June 29, 2011
NRC-11-0018

Subject: Enrico Fermi Atomic Power Plant Unit 1
Fermi 1 Groundwater Site Conceptual Model

In response to questions from the NRC staff's review of the LTP and "Report on Groundwater Characterization," Detroit Edison is submitting a new report on groundwater at the EF1 site, entitled "Site Conceptual Model" documenting the results of an assessment performed by Conestoga-Rovers & Associates. Revision 1 of the "Site Conceptual Model" is the first version of the report being submitted to the NRC.

figure 2
 AERIAL PHOTOGRAPH SITE MAP
 SITE CONCEPTUAL MODEL
 DTE FERMI 1
 Newport, Michigan

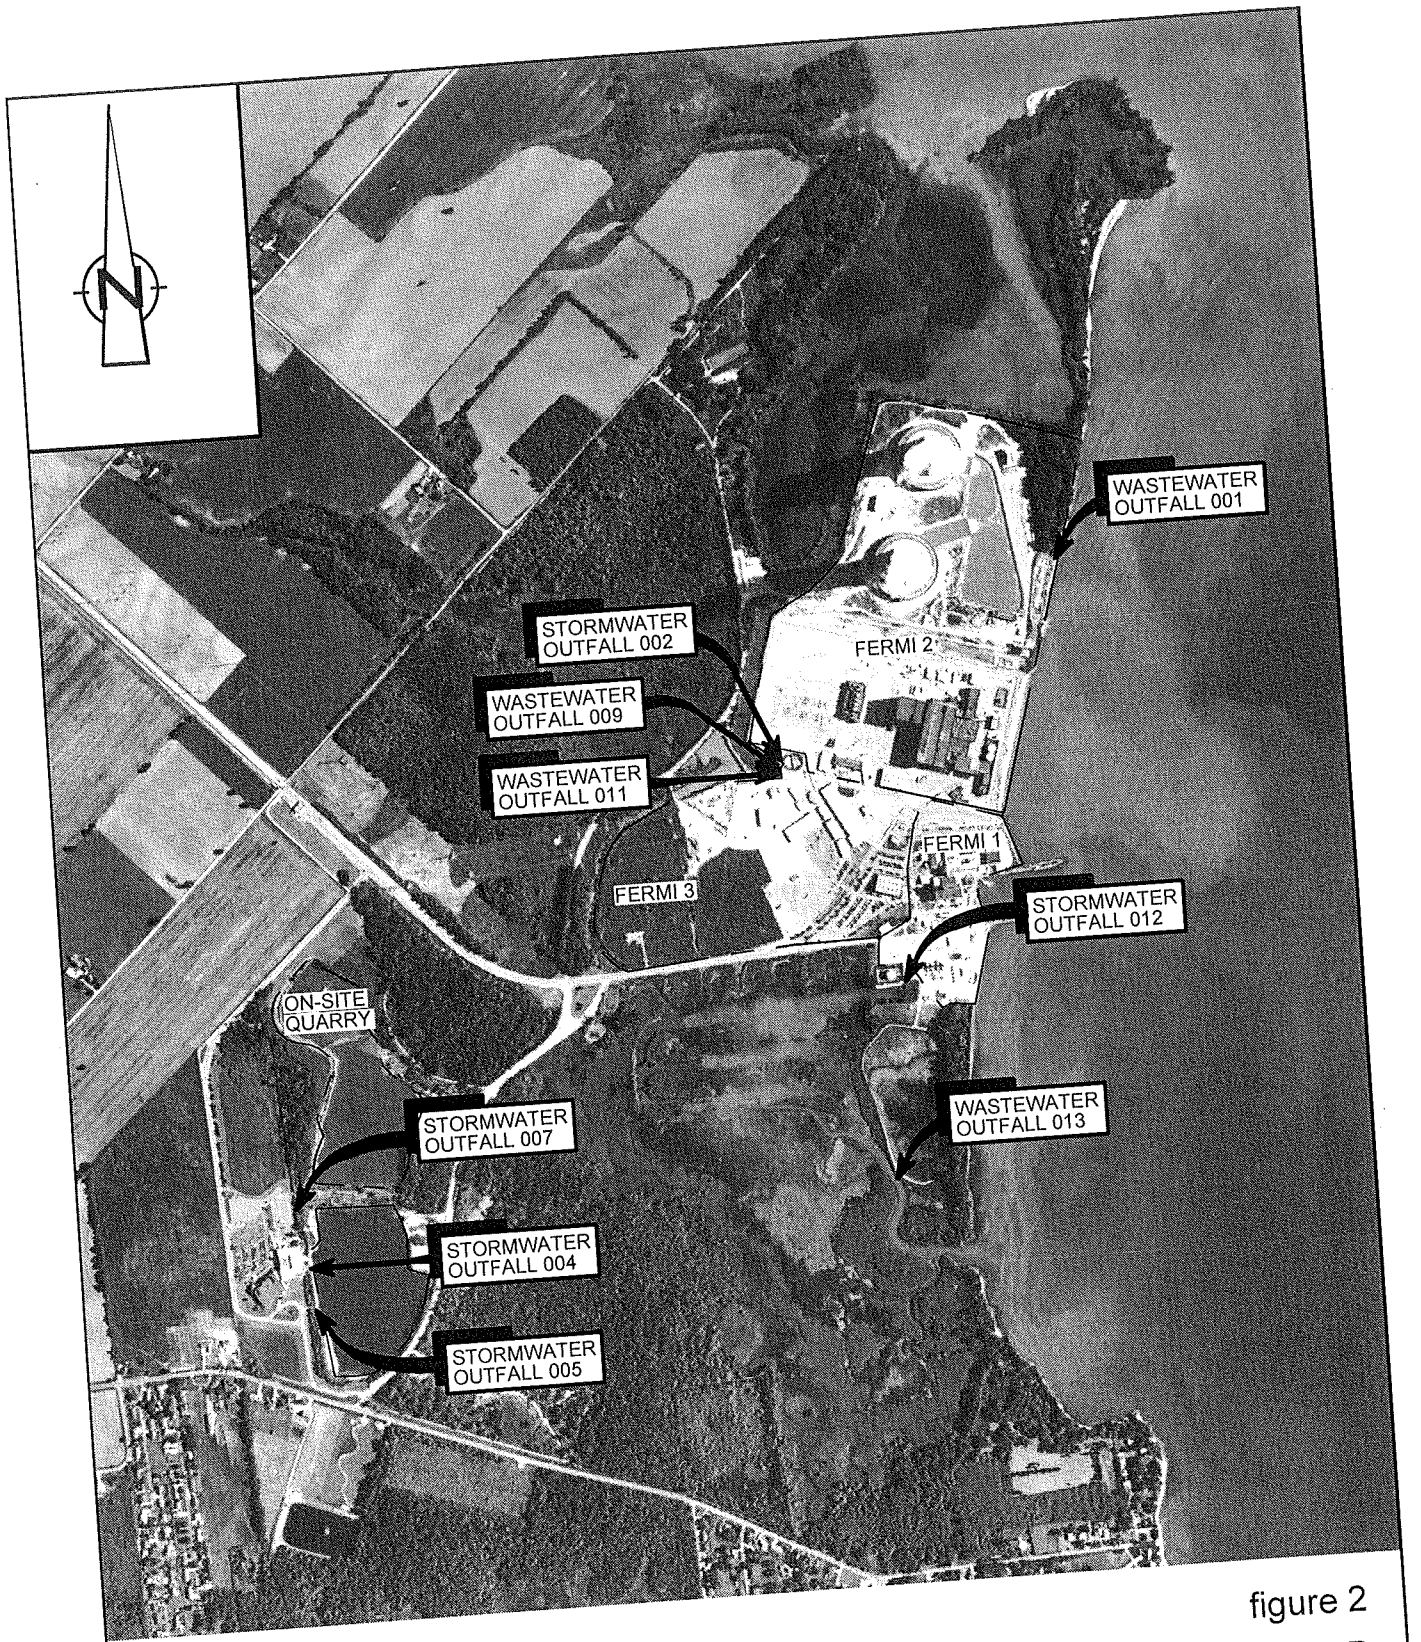
Question 4: The report states that Golder installed 16 monitoring wells at 11 locations, but figure 2 shows 15 monitoring wells at 10 locations. Please include monitoring well EFT-1I onto figure 2.

Response to Question 4: Figure 3 of Attachment 1, "Site Conceptual Model, Revision 1", shows the location of EFT1S, 1I and 1D, which are located adjacent to each other.
